**X63 REGIONAL AIRPORT / HURRICANE MARIA DISASTER RELIEF (DR-4339-PR)
PROJECT #85447 / MPPA057 HUMACAO REGIONAL AIRPORT
DR. HERMENEGILDO ORTIZ QUIÑONEZ AIRPORT, HUMACAO, PR**

ADDENDUM NO. 4

RE: PROJECT #85447/MPPA057-HUMACAO REGIONAL AIRPORT (HUC)
RESPONSE TO RFIs

**BID- 1.56
FOR
CONSTRUCTION SERVICES
TO RECOVERY PROJECTS
UNDER THE
FEMA PUBLIC ASSISTANCE PROGRAM FOR DISASTER
DR-4339-PR (Humacao Regional Airport (HUC) Humacao)**

1
2A-3.1
H2-SECTION A
SCALE: 3/16" = 1'-0"

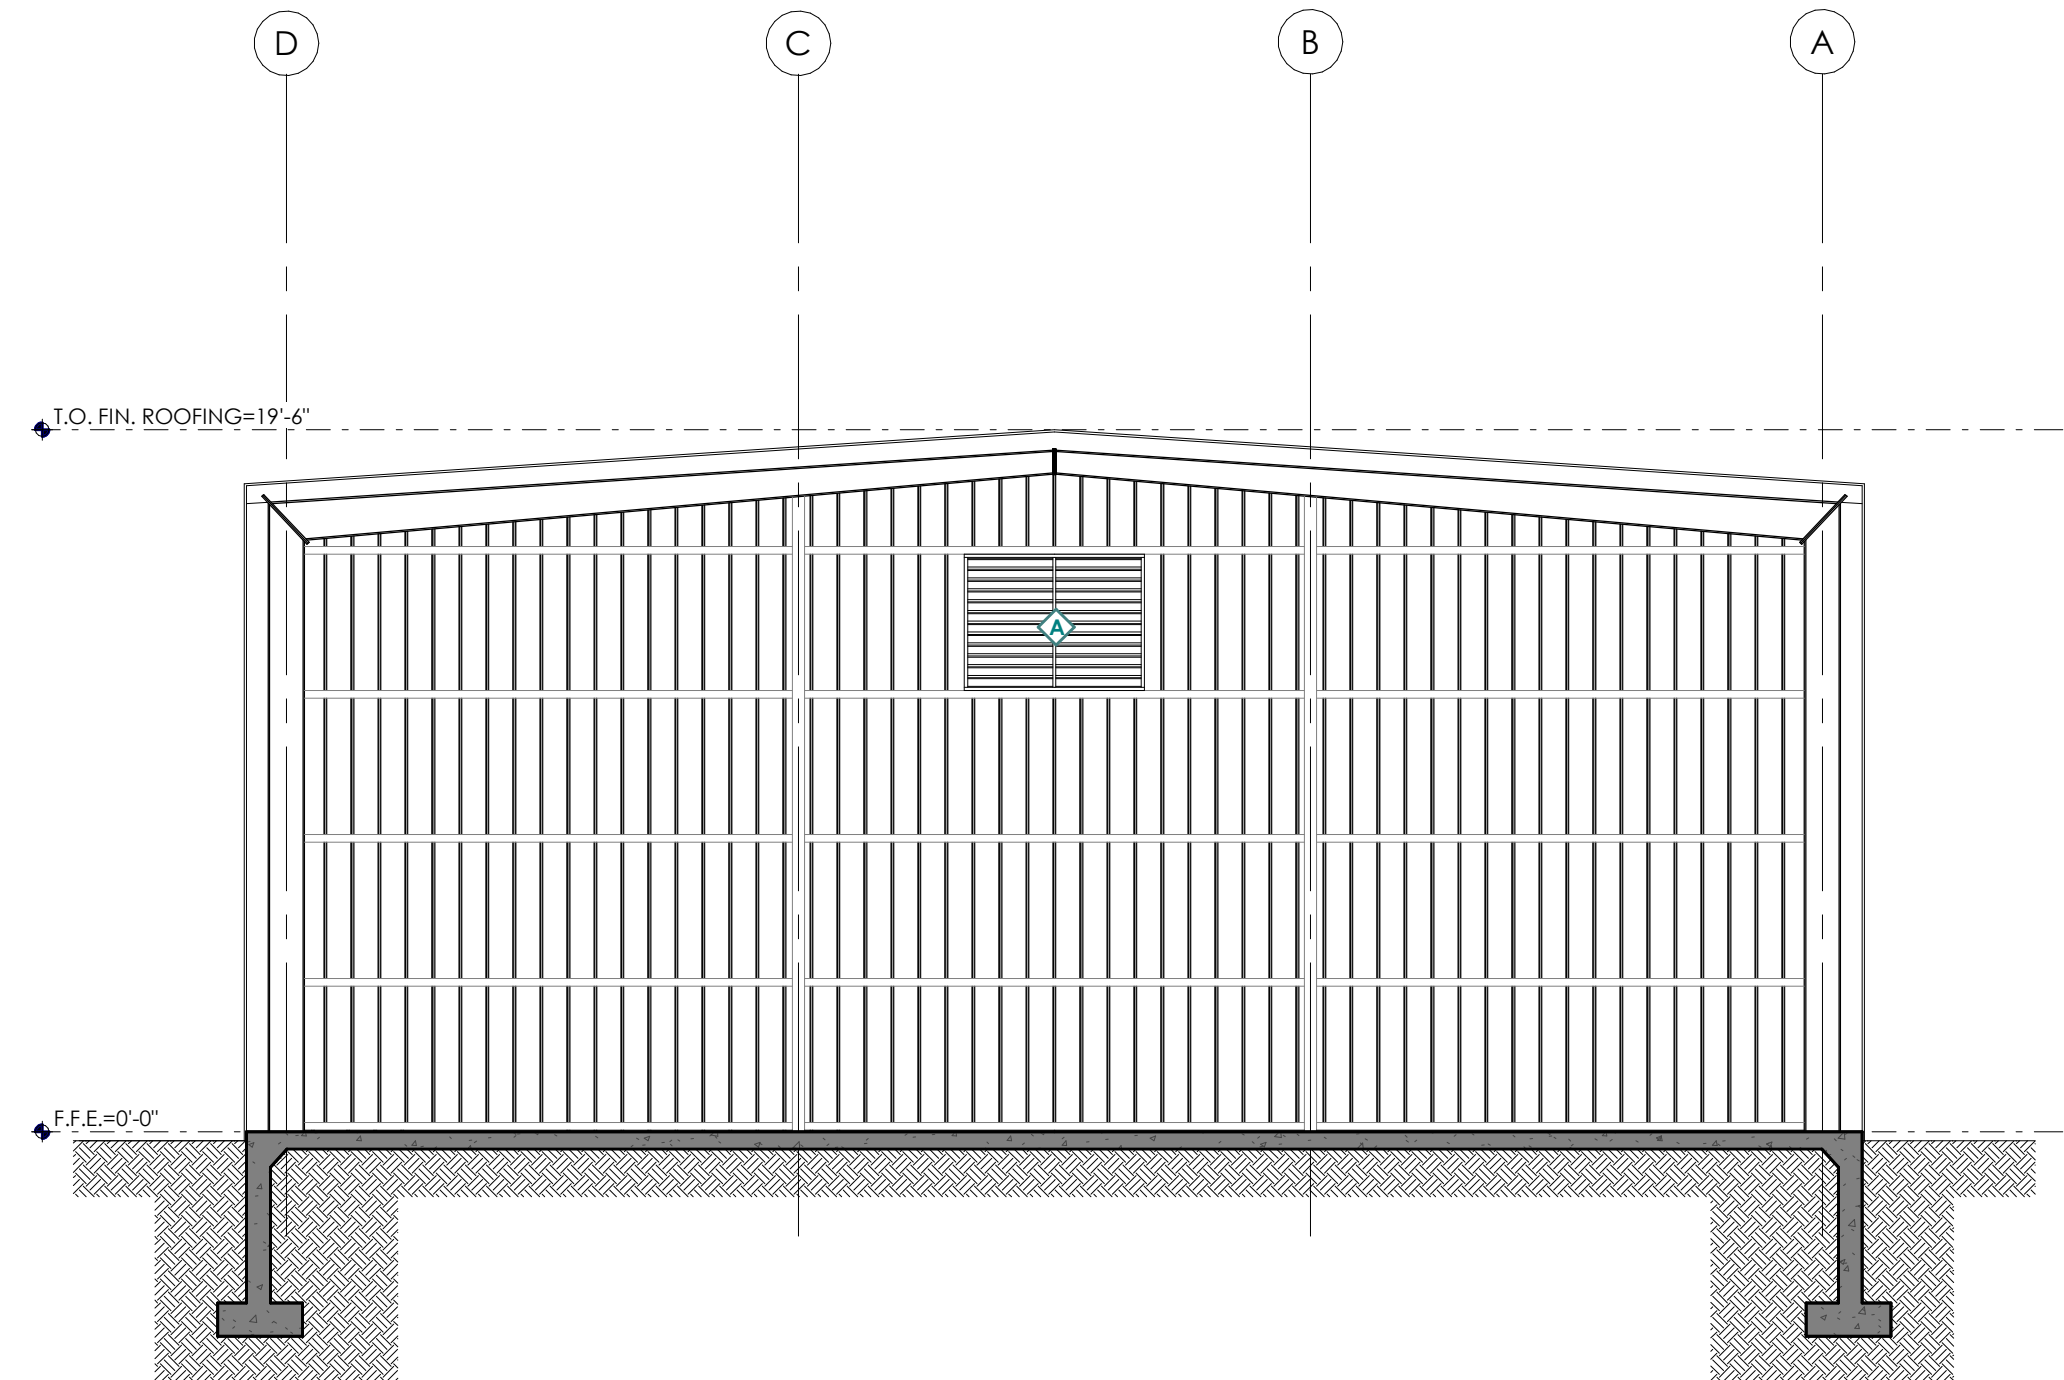
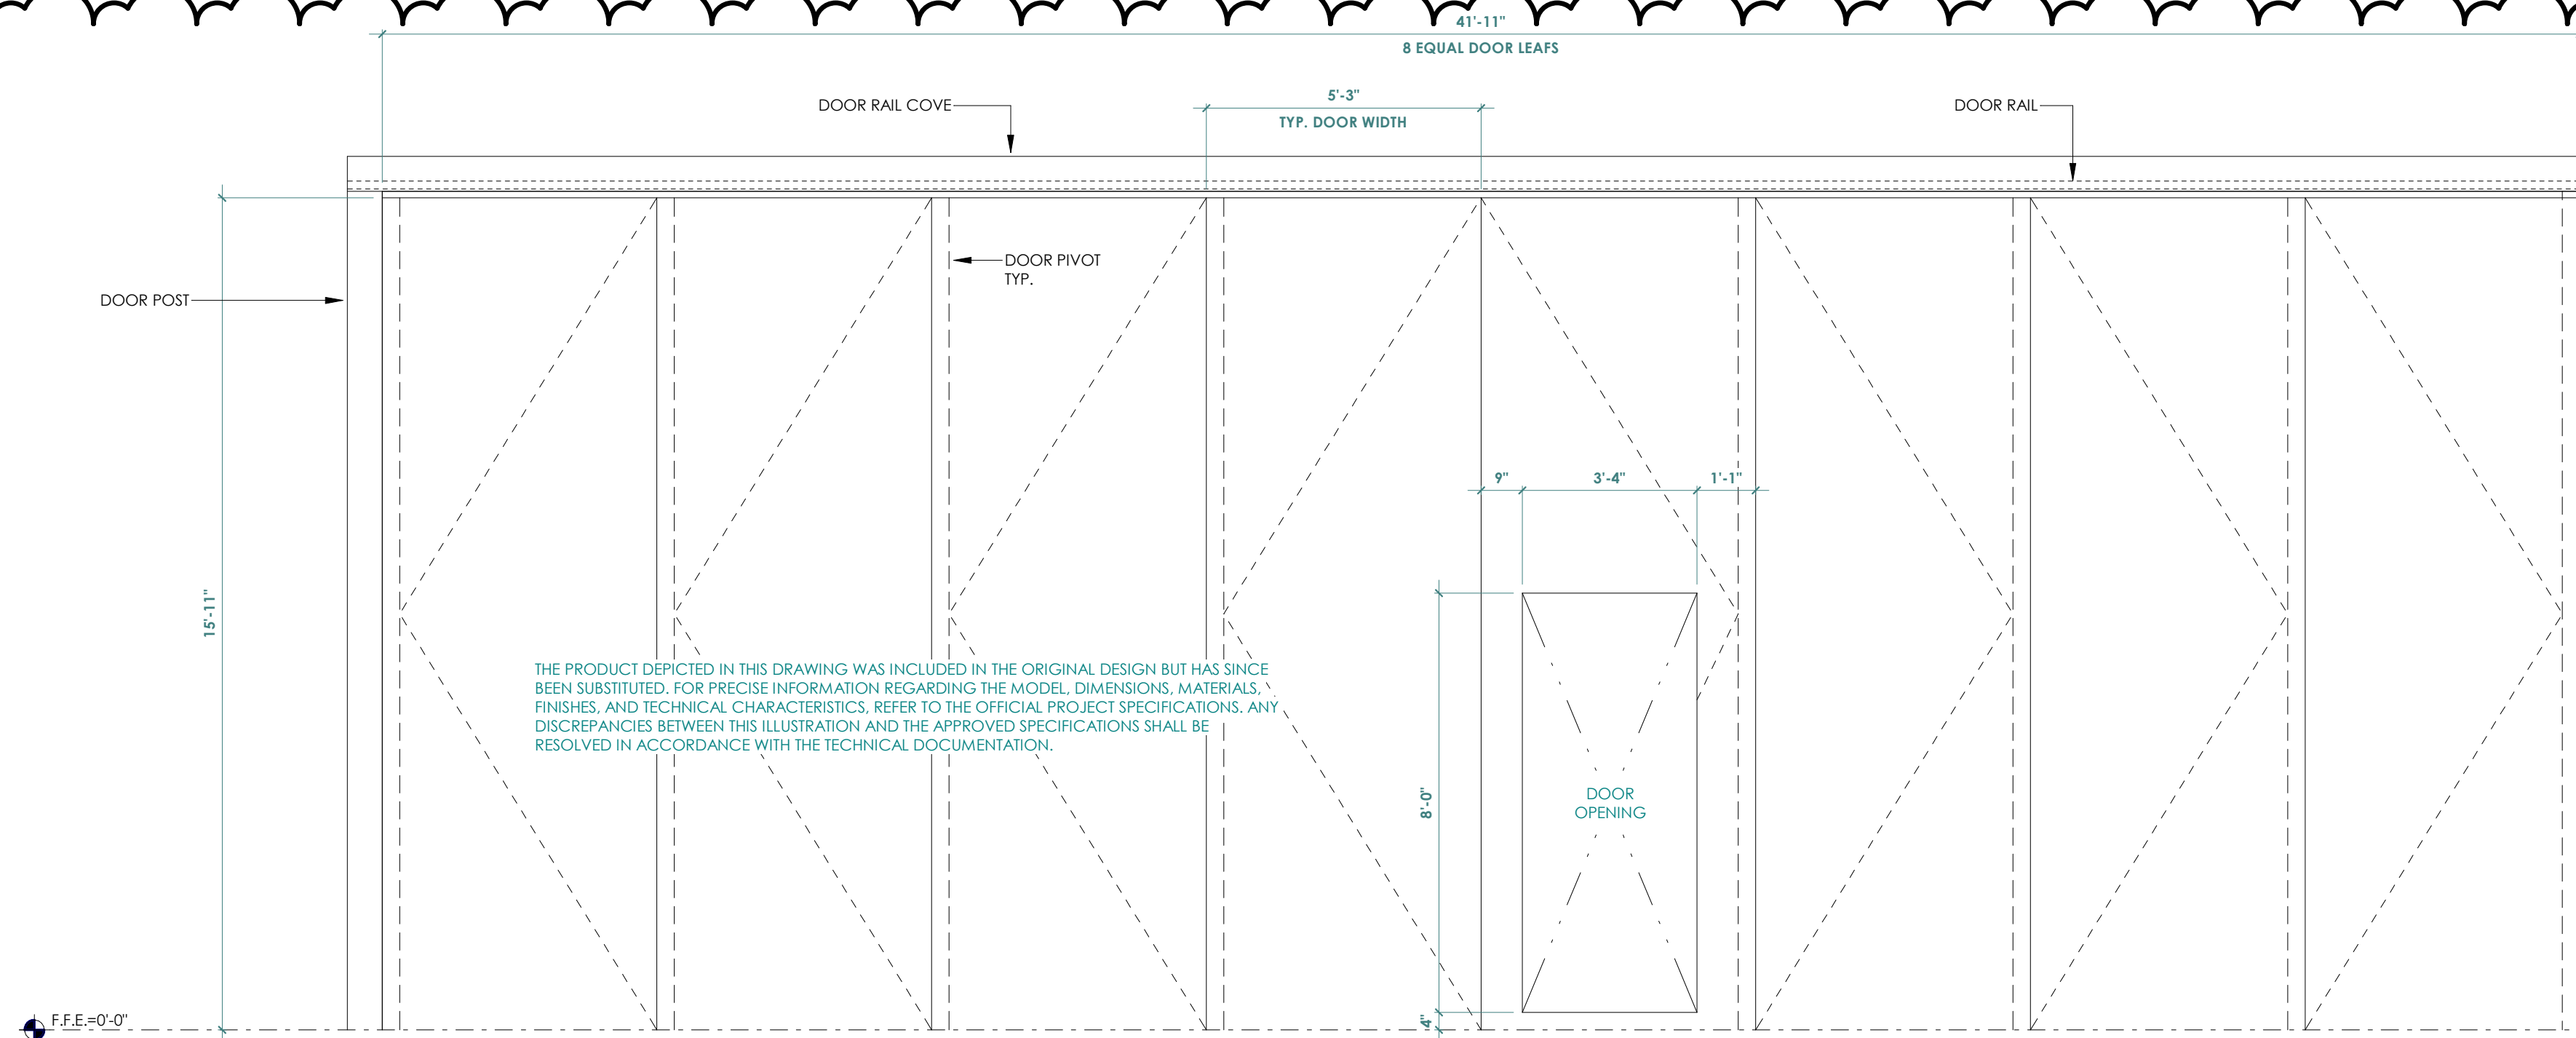
27	Because of the curved roof at hangar 3, using an overhead sectional door is not practical. But for new building 2, can an alternate be an overhead sectional door in lieu of the folding panel doors as shown on sheet 2A-3.1?	SLSCO LTD (SLSCO, LLP)	10/10/25	The type of hangar shown (arch and gable) are for illustration of the options available locally that the contractor may opt. As well, the contractor may select other types of doors if it complies with the minimum opening dimensions and the Puerto Rico Building Codes-2018. The products shall be submitted to the PRPA for review and approval.
28	South Elevation on sheet 3A-2.1 indicates the new hangar doors. Please provide more information about how the doors will open, stack, etc. Please include overall dimensions of each door leaf as shown. Is the architect open to suggestions as per the hangar door	SLSCO LTD (SLSCO, LLP)	10/10/25	For this hangar #3, the existing doors shall remain. An alternative option for the hangar doors was added specifically for Hangar 2. These notes are under review and will be corrected and included in the appropriate location in the drawing sheets.
